# FINDINGS AND RECOMMENDATION OFFICE OF PLANNING AND ZONING ANNE ARUNDEL COUNTY, MARYLAND

**CASE NUMBER**: 2023-0112-V

# **REQUEST**

The applicants are requesting a variance to allow an accessory structure (detached garage) with less setbacks than required on property located at 1128 Long Point Terrace in Annapolis.

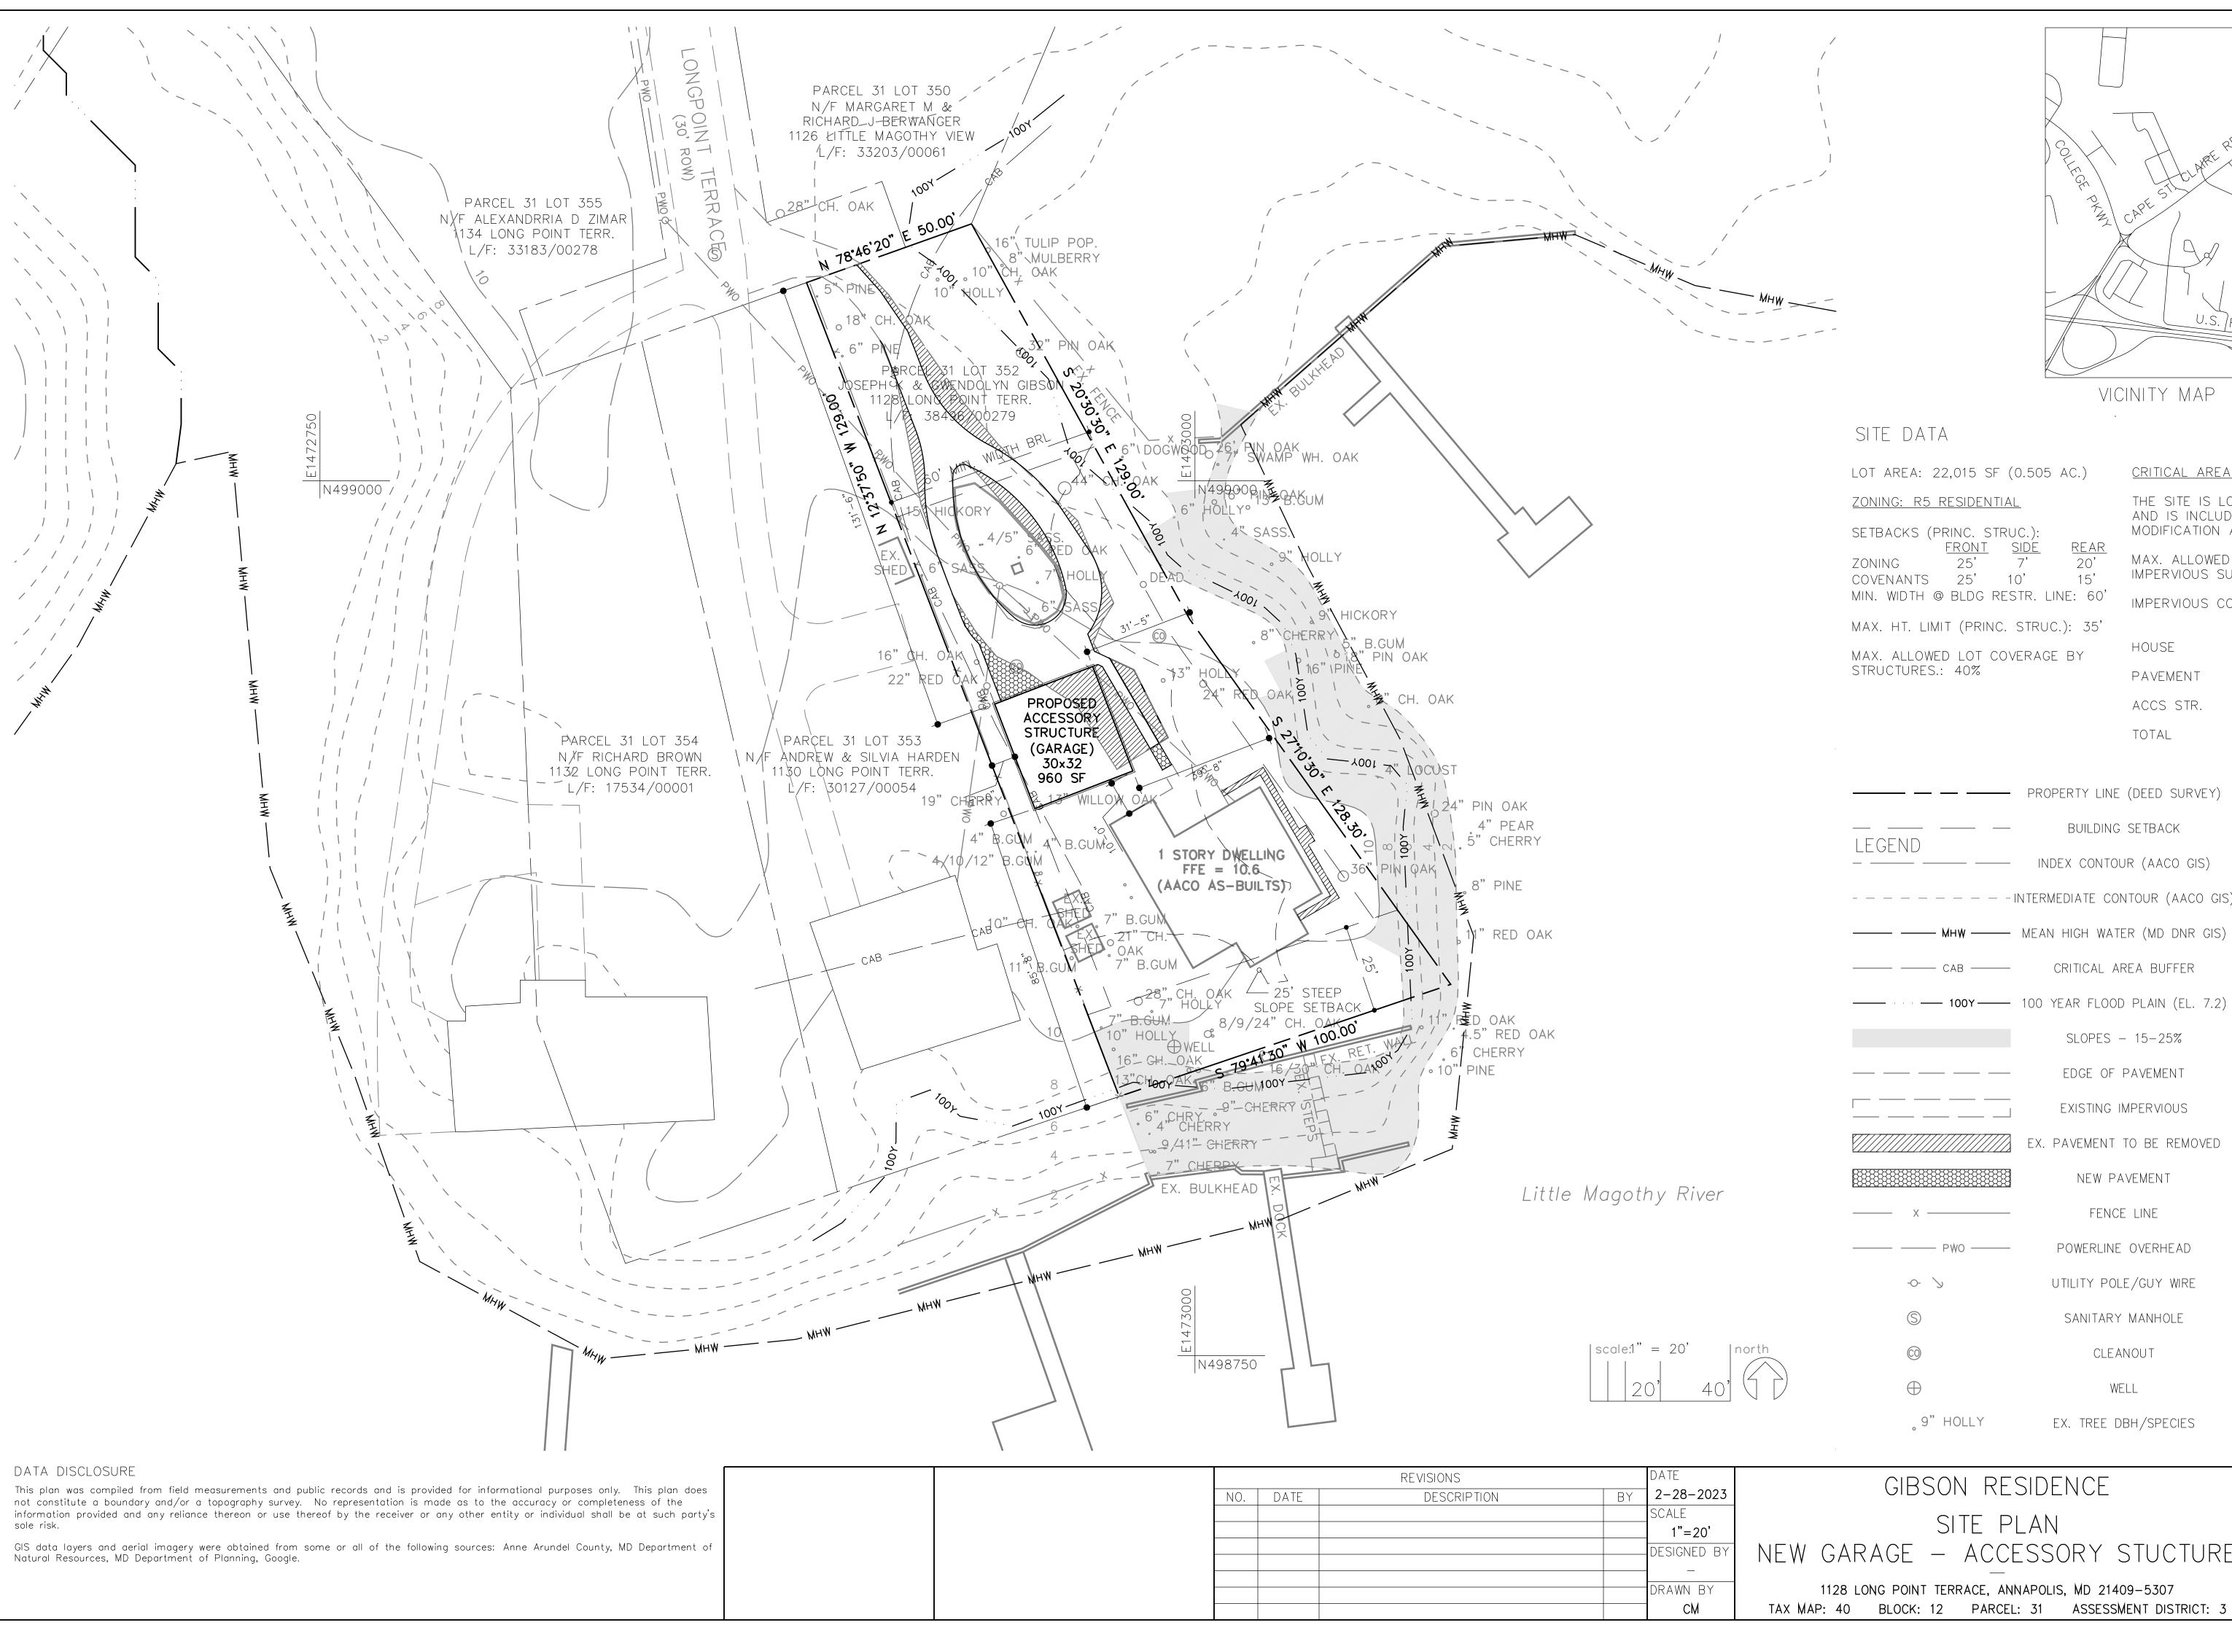
In this particular case, the property is unique, in that it is relatively narrow and has frontage on two sides (east and south). The applicants are proposing to construct the detached garage at the minimum setback to the western side lot line, in order to be as far from the eastern front lot line as possible. However, the proposed garage is oversized at 30' x 32'. Reducing its width in order to meet the front setback would still result in a sizable garage<sup>1</sup>. The applicants have not provided any justification to demonstrate that the garage could not be constructed in compliance with (or at least closer to) the minimum forty foot setback required from the eastern front lot line.

However, it appears that alternative options exist that would minimize or eliminate the need for a variance. Without sufficient justification, the variance request cannot be considered the minimum necessary to afford relief. As such, this Office does not support the proposed variance to \$18-4-701 for the detached garage.

<sup>&</sup>lt;sup>1</sup> Alternatively, if the detached garage were instead made part of the principal structure, the front setbacks would be 25 feet to the front (east) property line. Per § 18-2-204(a), a structure located within three feet of a principal structure and a structure connected to a principal structure by an enclosed breezeway less than 15 feet long is part of the principal structure and is not an accessory structure.
